**City Mark Capital Art Project  
City Response to Artist Questions  
July 17, 2024**

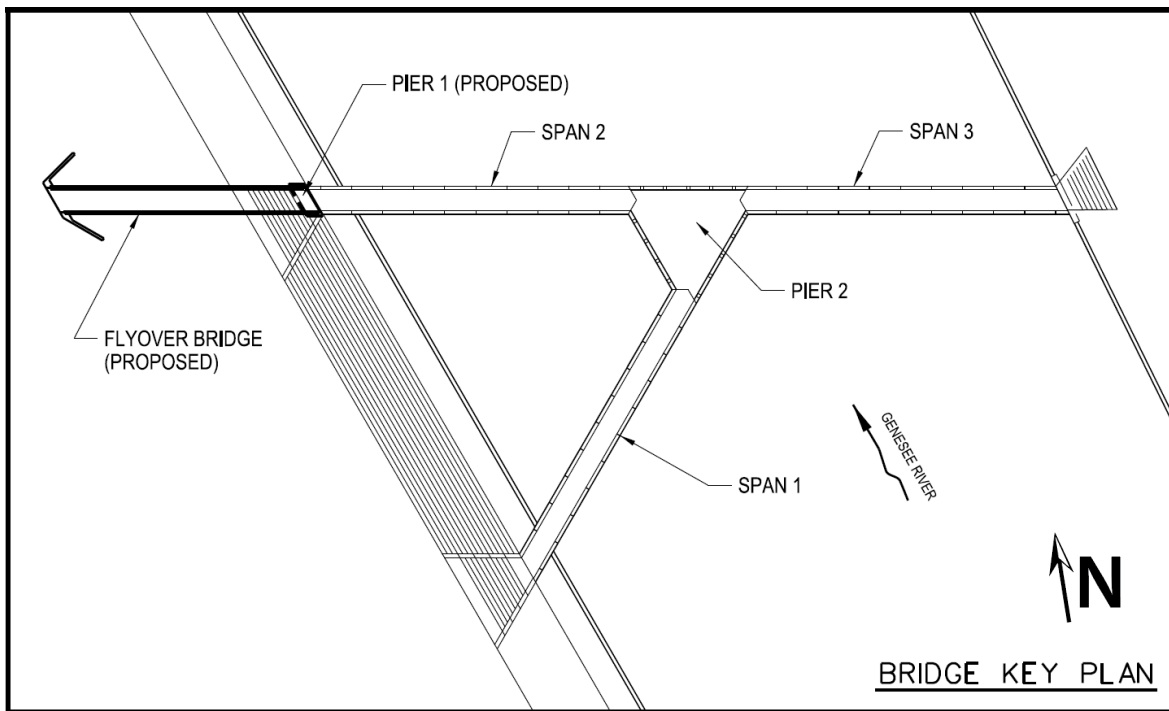
**Q8: What are the structural components under the bridge?**

In summary, the structural components under the bridge (noted in the diagram below) consist of:

- Span 1 & 3: Consist of post-tension concrete T-Beam. A four-inch concrete overlay is placed on top of the concrete T-Beam.
- Span 2: Consists of a post-tension concrete T-Beam. A three-inch concrete overlay is placed on top of the concrete T-Beam.
- Flyover Span: Consists of a six and a half inch concrete deck supported by steel beams.
- Pier 2 (Center pier located in river): Consists of a reinforced concrete pier founded on rock. The pier contains six sides, each side is angled and decreases in width as the elevation decreases.

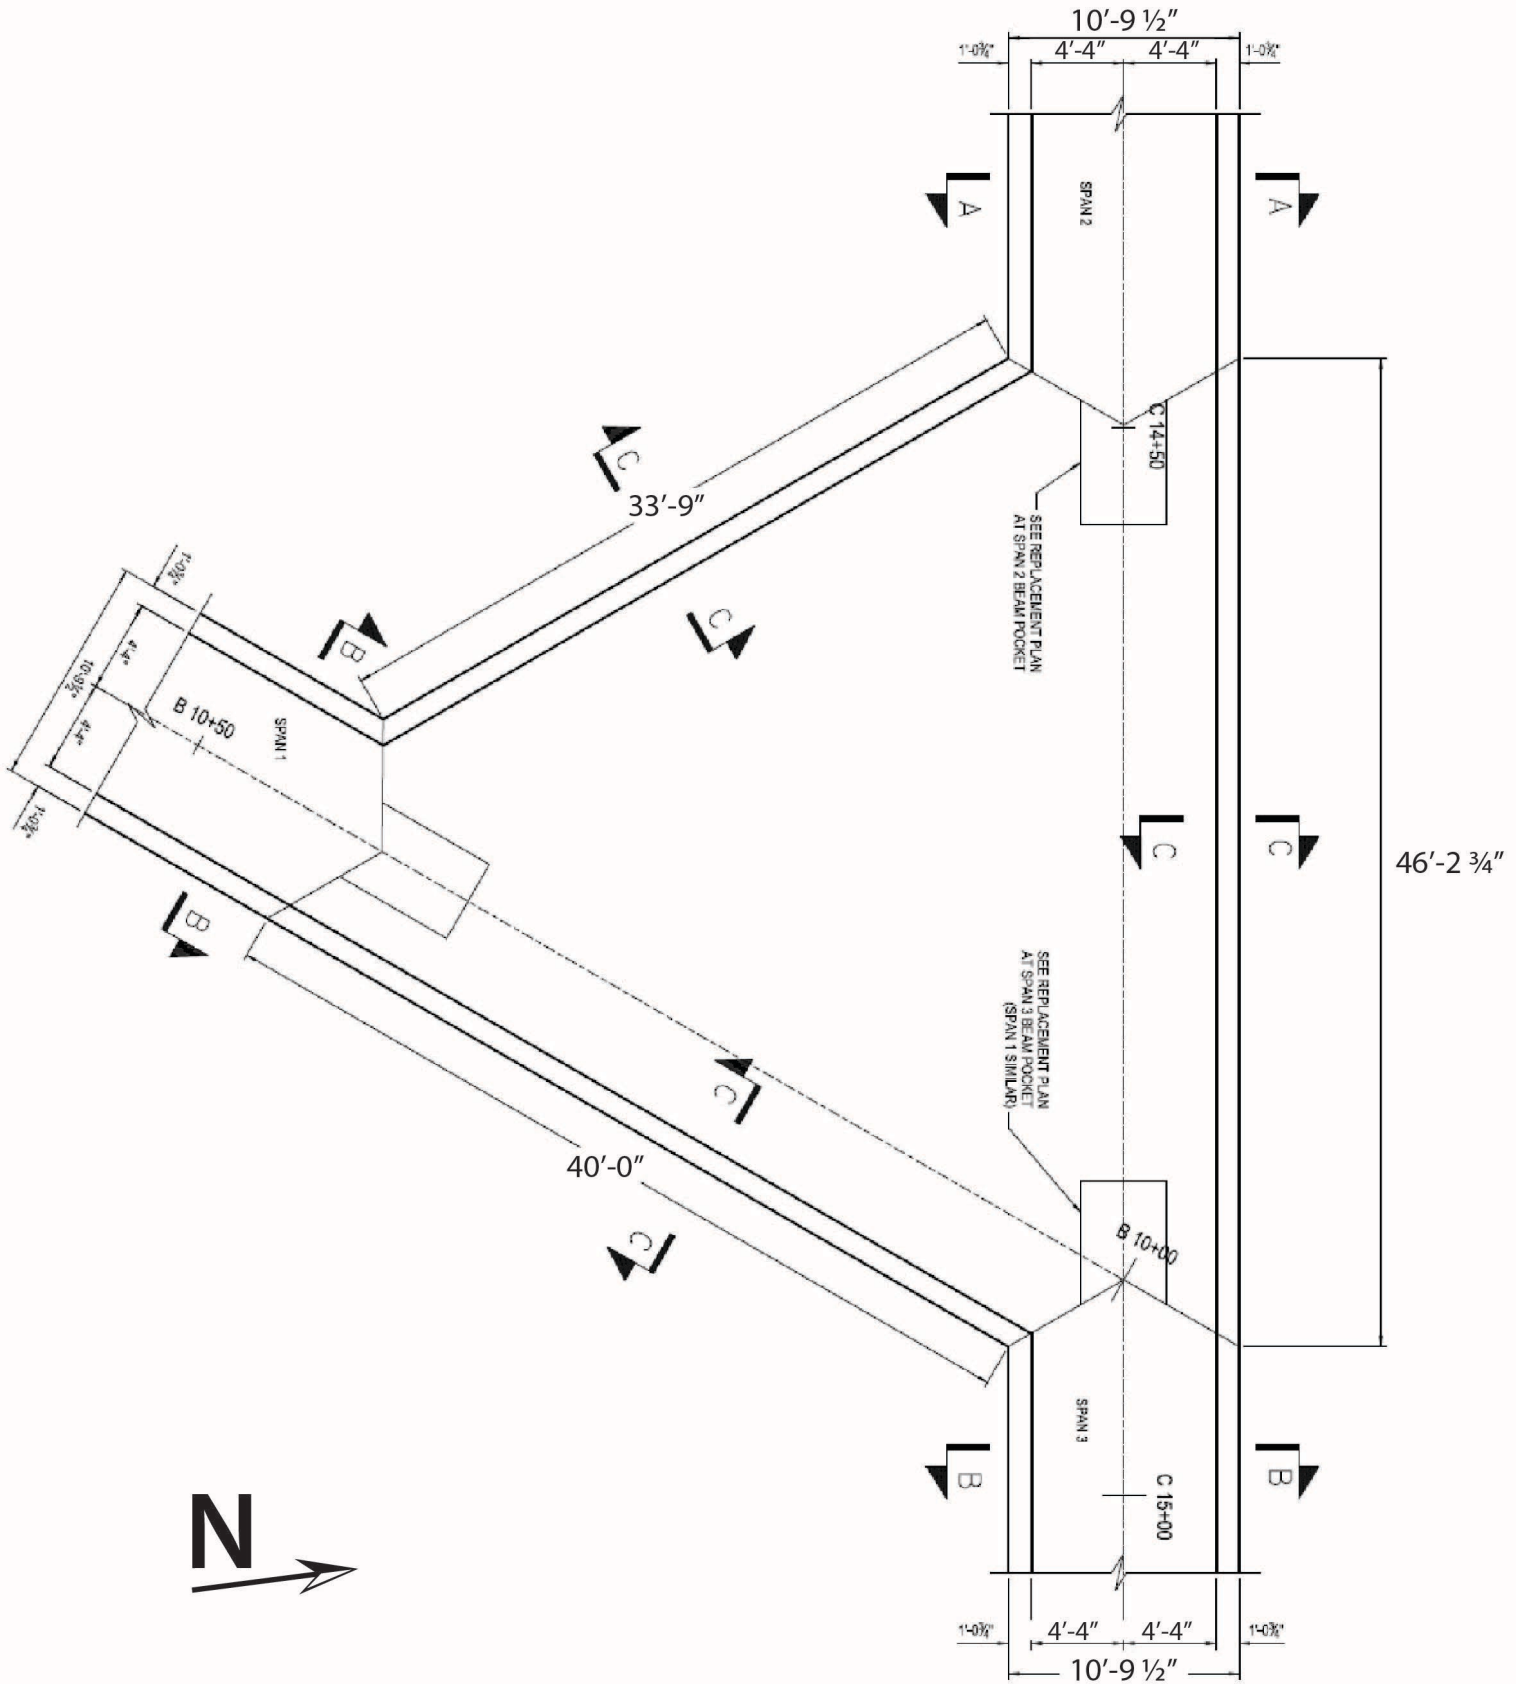
**Q12: Are there approximate weight, height, or overall dimension limitations for the focal point project?**

The bridge weight limit is 5.3 tons. The height and overall dimensions of the structure shall be determined by weight and stability calculations performed by an engineer licensed in the State of New York. Stability calculations shall take all applicable loading into account (e.g. wind, snow). The City does not wish to restrict the creativity of Artists in preparing their submissions. However, we offer the following parameters that will be required for maintenance, snow removal, pedestrians, and cyclists.

- **OVERHEAD CLEARANCE:** An overhead clearance of 10' above the walking surface is required on all pathways.
- **HORIZONTAL CLEARANCE WIDTH:** The route from the flyover bridge to span 2 and through span 3 (along north side) is the accessible route, and a horizontal clearance width of 8'8" needs to be maintained along this route. We recommend that the same horizontal clearance width is maintained along span 1 through the pier to span 3, but the minimum required clear width is 5'.
